No. 2020  
ATA Code 71-00

## Kit No. 76-5005-1 S

**SUBJECT:** POWERPLANT - INSTALLATION OF SPACER BETWEEN THE CARBURETOR AND ENGINE

**EFFECTIVITY:** BEECHCRAFT Duchess 76, serials ME-1 through ME-437.

**Spacer Installation**

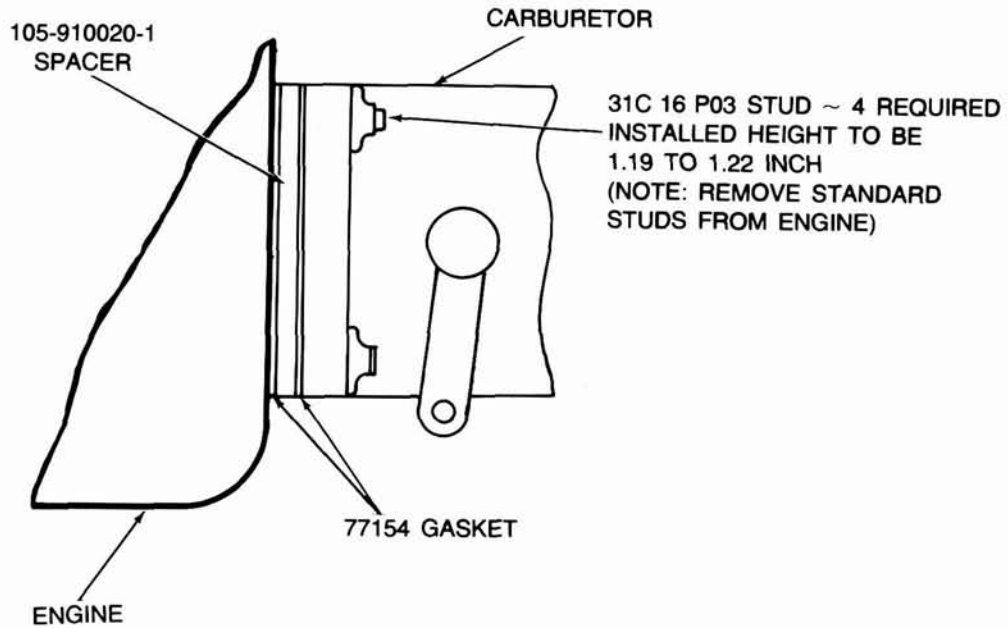
**REASON:** To reduce the possibility of the carburetor coming in contact with the engine mount.

5. Install two new P/N 77154 gaskets, a P/N 105-910020-1 spacer and reinstall the carburetor on the new mounting studs as shown in the illustration. Use the nuts and Pal nuts which were removed in Step 3.

4. Carefully remove the four mounting studs from the engine and install four new P/N 31C16P03 studs.
